CRITICAL ANALYSIS OF DAVIS/ MOON 2015 PRESENTATION ON PARTICLE BOARD CABINET THICKNESS SWELL

6-25-18

Peer Reviewers. Reviewers Of Our Critique of Moon 2015

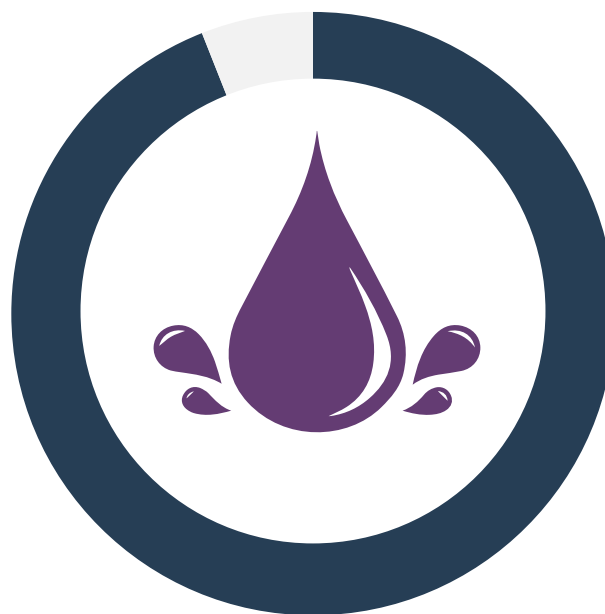
>**94%** humidity
under which
Moon study was
performed is not
the real world.

Any knowledgeable reviewer would question whether a study at >94% humidity is in any way useful or a reliable technique for estimating the duration of a water loss in a real-world air conditioned home.

Age Impacts TS Height

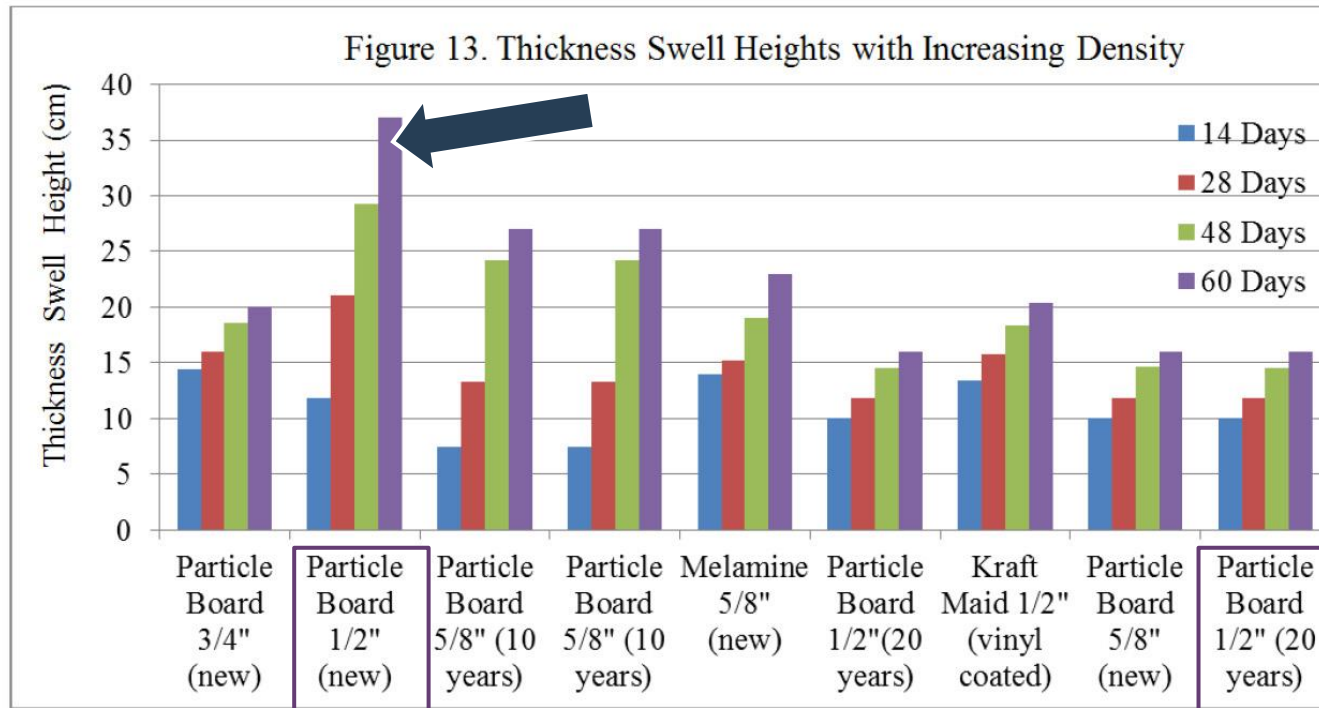
- Let's take a look at Moon's data for 20 year old 1/2" particle board. And compare it to 1/2" new particle board.

Age Impacts TS Height

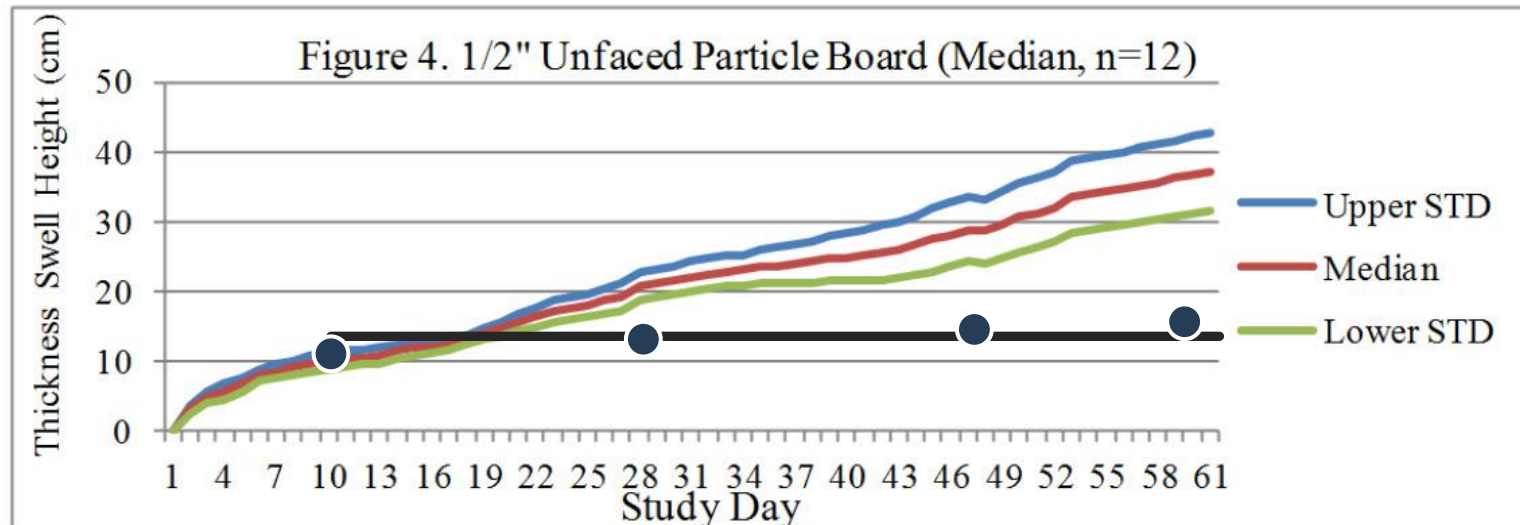
- Lets put the 20 year old data points (14 days = 10 cm; 28 days = 12 cm; 48 days = 14 cm; 60 days = 16 cm) onto Moon's Fig 4 plot of the 1/2" new.
- The older particle board (●) shows NO SIGNIFICANT increase in TS height after the first 14 days.
- Since older particle board has NO significant increase in TS height after the first 14 days.
- And since rarely are kitchen cabinets brand new.
- Moon's theory that you can measure TS swell and determine water loss duration has No Merit.

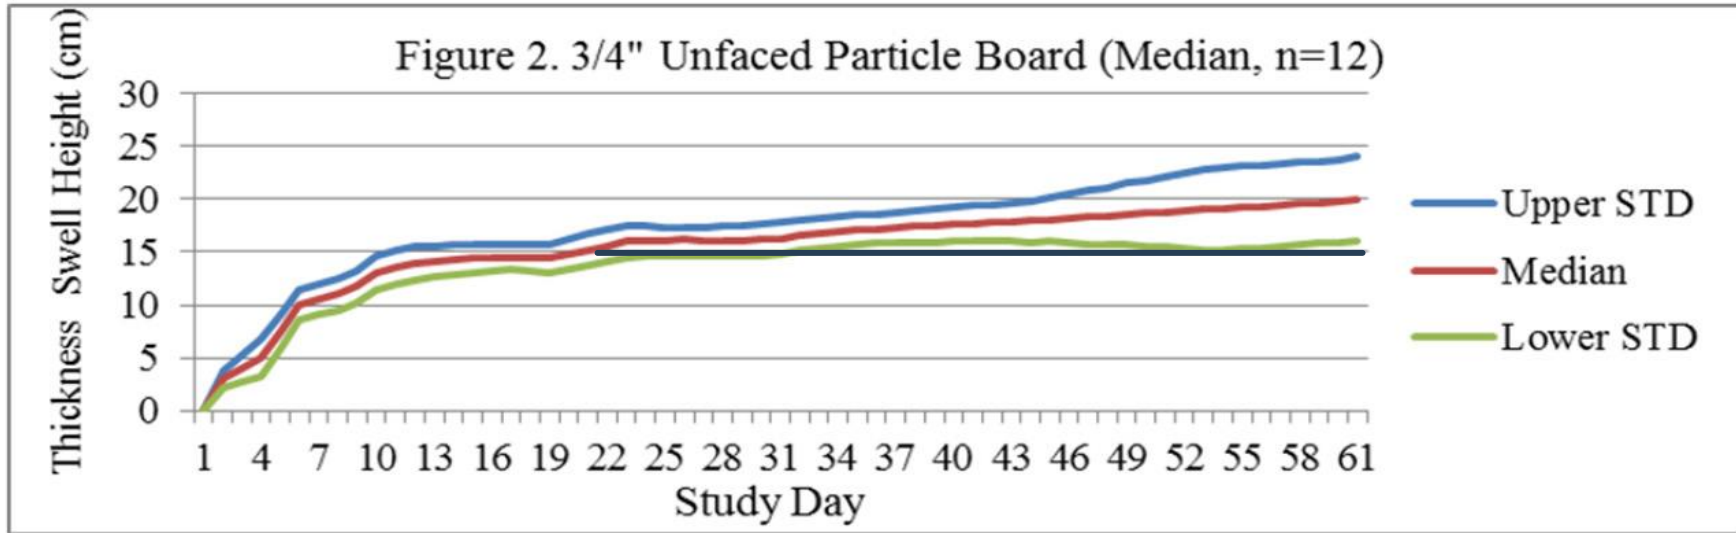
- The lower STD line is the same between Day 23 (or so) and day 54 (or so.)
- This means that within the error bounds of Fig 2, there is NO increase in TS over time for 3/4" Unfaced Particle Board.

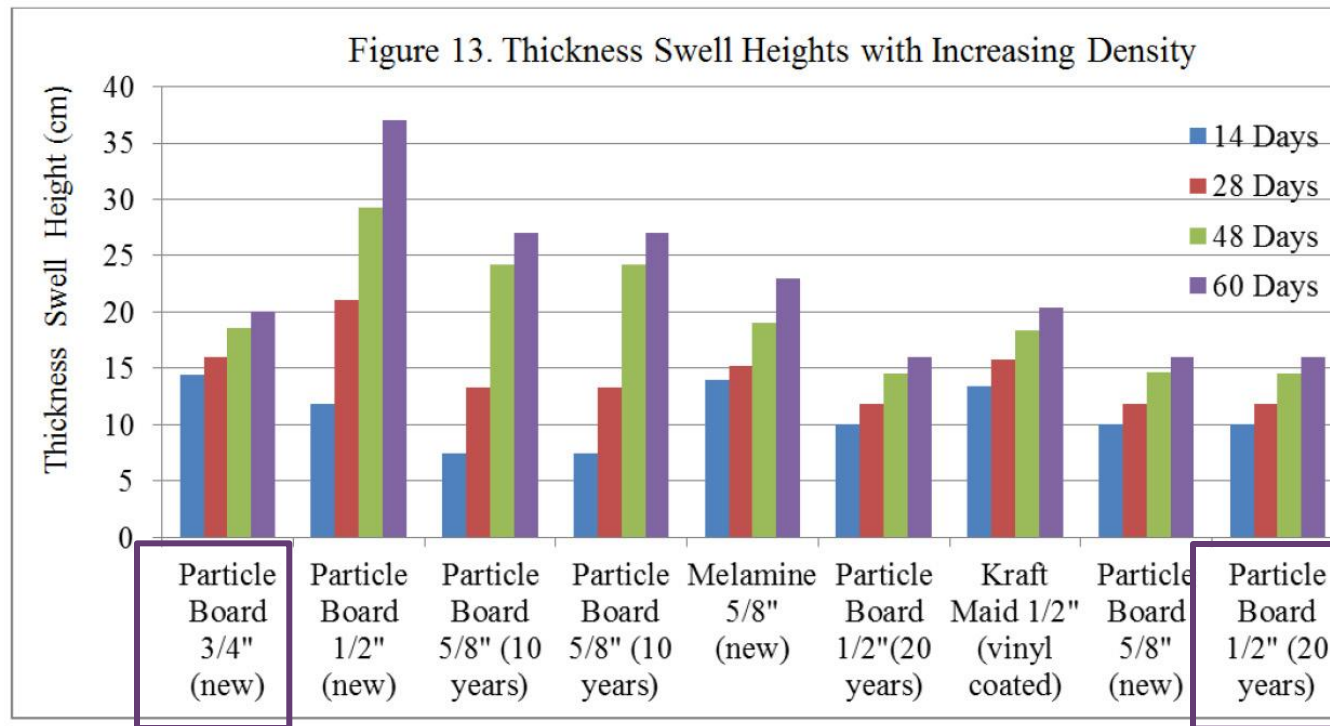
Per Moon conclusion, the TS rates are fastest with thin panels.

Slower with thick panels.

Typo in Fig 6

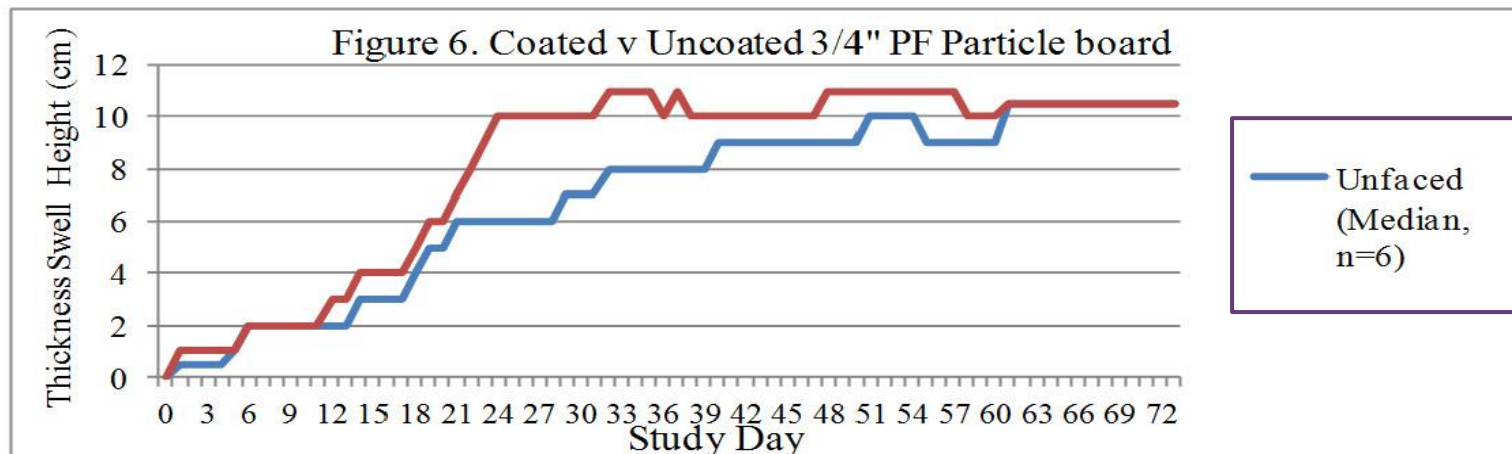
- There is no legend for the red line which is faced panel.
- Even the least sophisticated reviewer would find these types of problems. And there are so many of them.
- **Not Peer Reviewed.**

Another Error

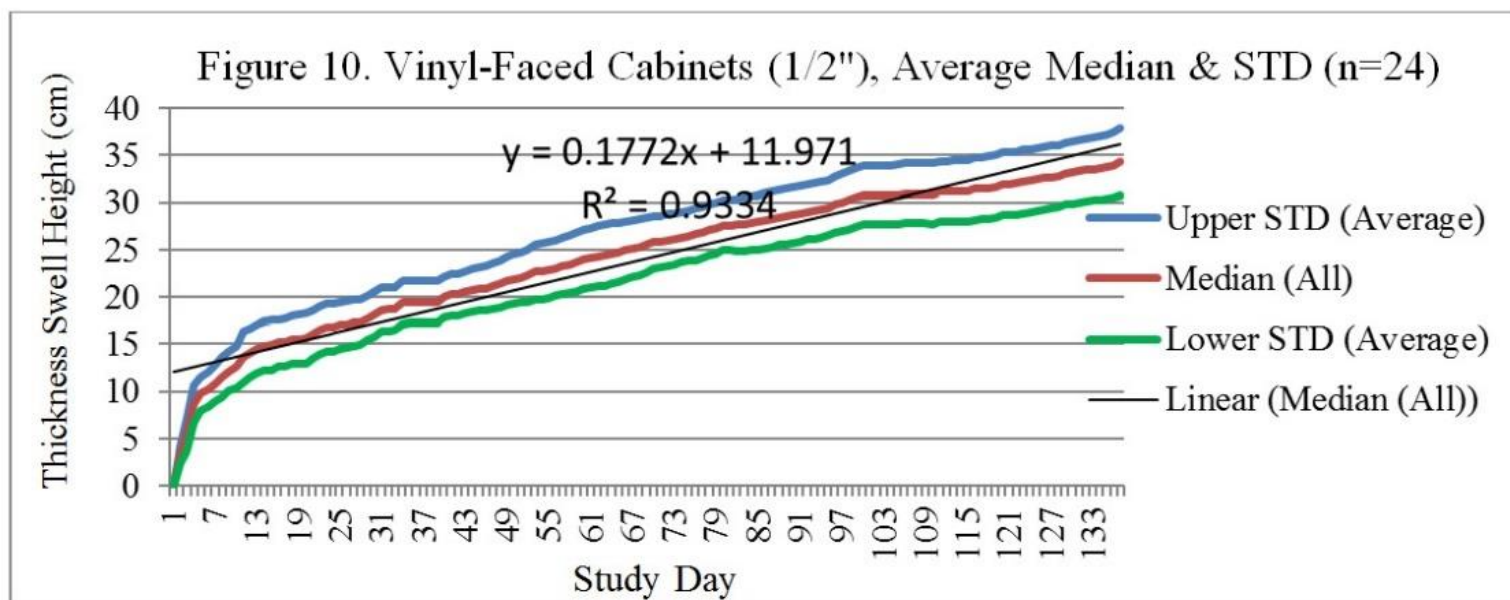
- Moon says under Fig 10: "vinyl cabinets (Figure 11)".
- But Fig 10 is Vinyl. Fig 11 is Melamine. This mistake shows that the article was never professionally reviewed. **Not Peer Reviewed.**

These Two Graphs Similar? NOT

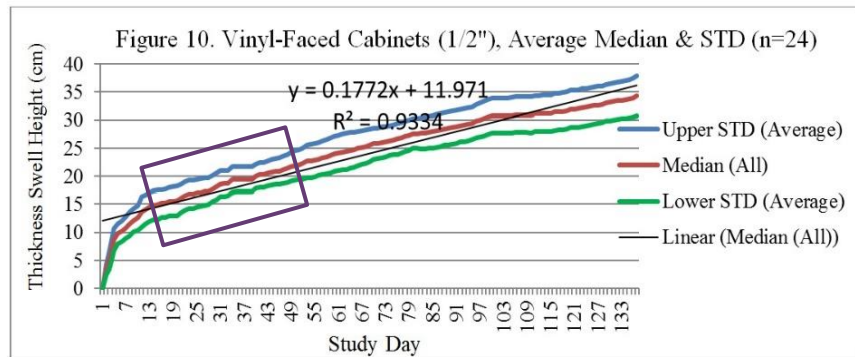
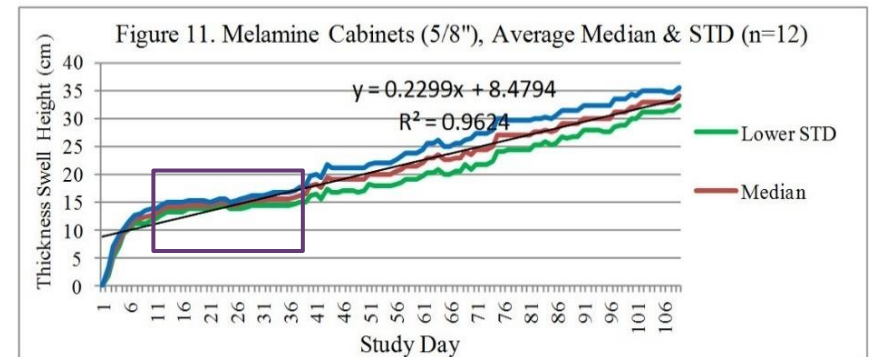
- Moon says: "similar". But the Melamine cabinet TS is flat between Day 11 and Day 41! Vinyl TS is not flat.
- No competent reviewer would allow someone to say the TS rates in these graphs are similar. **Not Peer Reviewed.**

Moon Says Vinyl vs Melamine Equations Similar

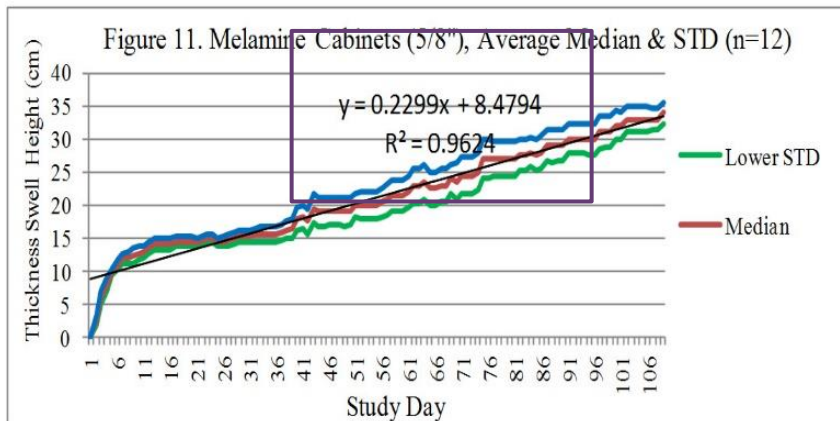
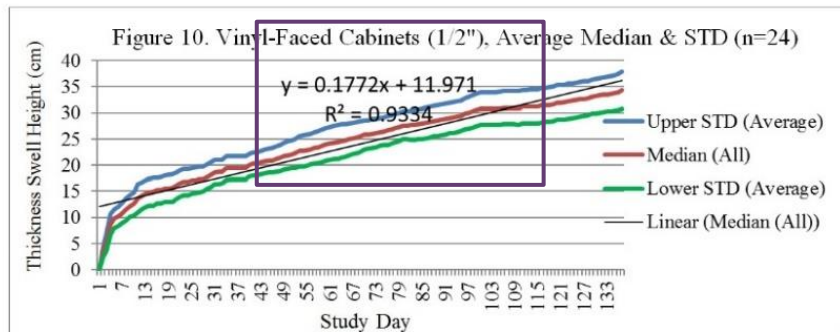
- Melamine equation is:
 $Y = 0.2299x + 8.4794$
- Vinyl equation is:
 $Y = 0.1772x + 11.971$
- Vastly different equations.
- No competent reviewer would say these are similar equations.
- Not Peer Reviewed.

Swelling Rate. NOT Similar

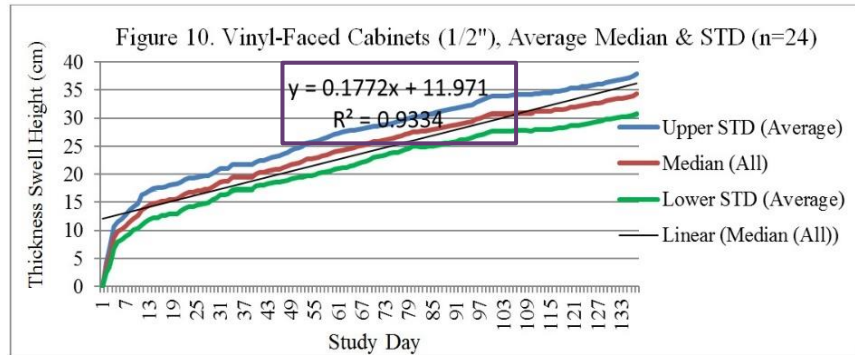
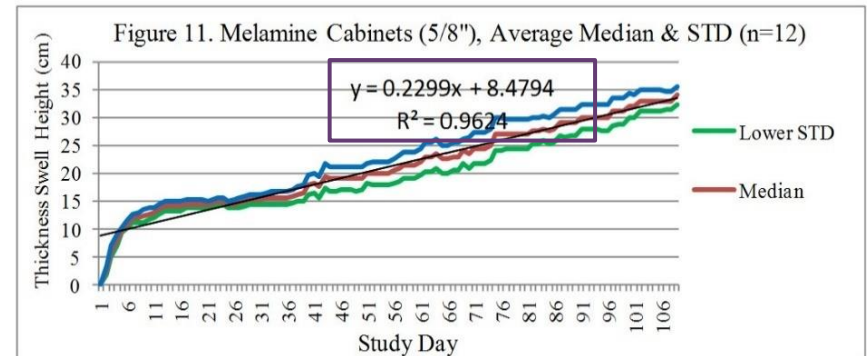
- 0.2299 and 0.1772 are the slopes of the equations and stand for increase in swelling per day (Swelling Rate).
- The Melamine slope is 30% faster but Moon concludes that they are similar.
- No competent reviewer would allow someone to say the equation slopes are similar. **Not Peer Reviewed.**

Fig 4 ½" Unfaced vs Fig 10 ½" " Vinyl Unfaced

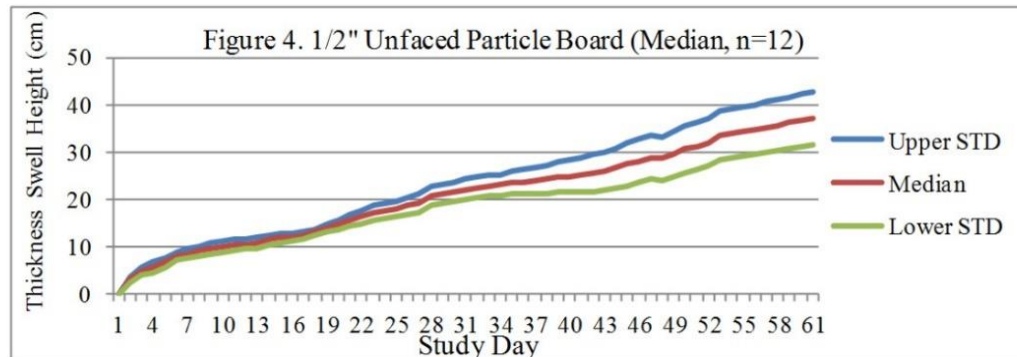
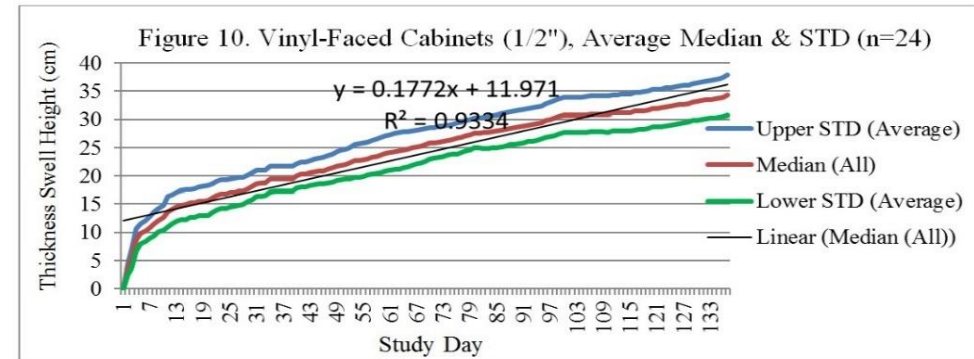
- Saying that these two graphs (both ½") are the same makes no sense.
- And shows that this article was not subjected to serious professional review.

Yet, Moon concludes no difference. Not Peer Reviewed.

More On Figure 11 5/8 Melamine (Typical Cabinets).

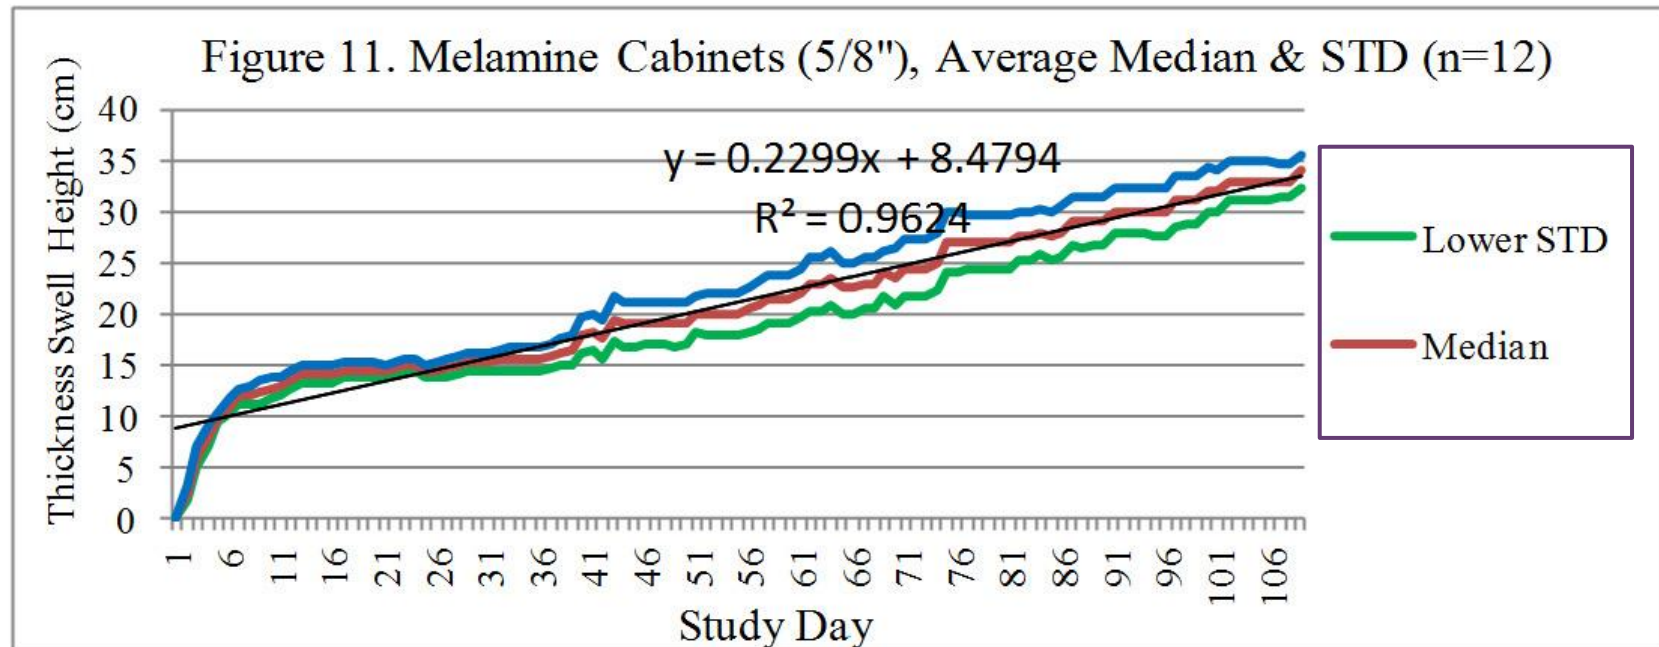
- Figure 11. See red rectangle. Moon forgot to label blue line.
- No competent reviewer has carefully reviewed the Moon graphs or they would have found this incorrect labeling. Not Peer Reviewed.

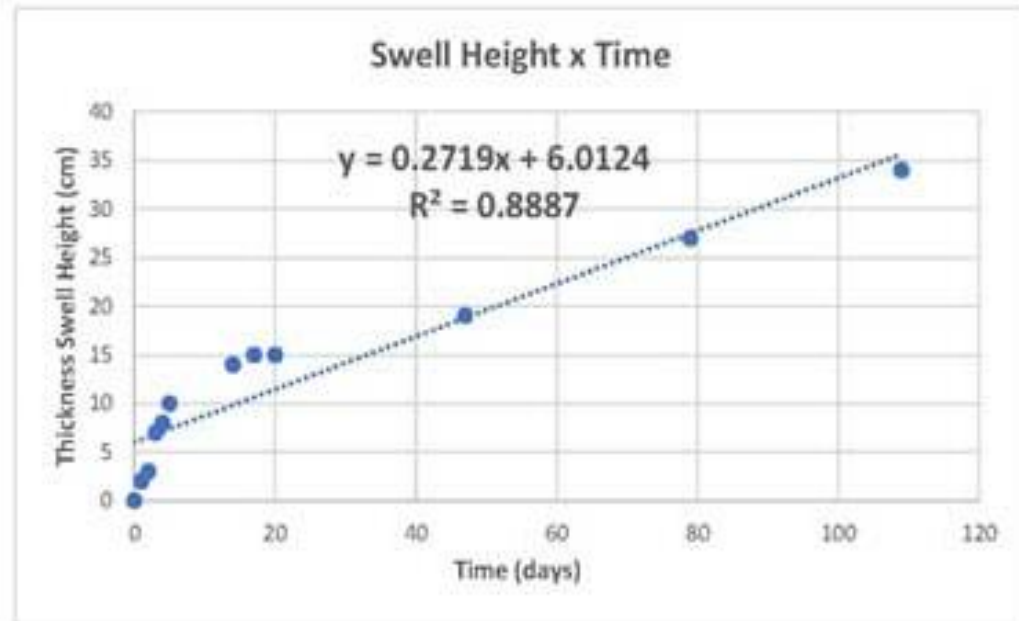
- We attempted to reproduce Moon's Fig 11 with data extracted from Moon's Fig 11 graph.
- With Moon's own data, we get $R^2=0.8887$ which is a poor fit and not $R^2=0.9624$ that Moon (says he) got which is an awesome fit.

More on Fig 11 Regression Analysis

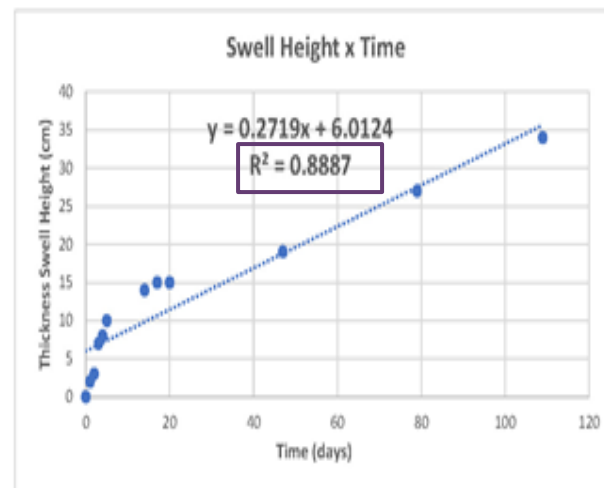
- Moon comes up with very a high R2 (.9624) by manipulating the data.
- Using 12 points from his graph we obtain a poor R2 (.8887).
- Who is right? Who is wrong? Same data.
- No way to know. Moon does not include data points. Only the graph.
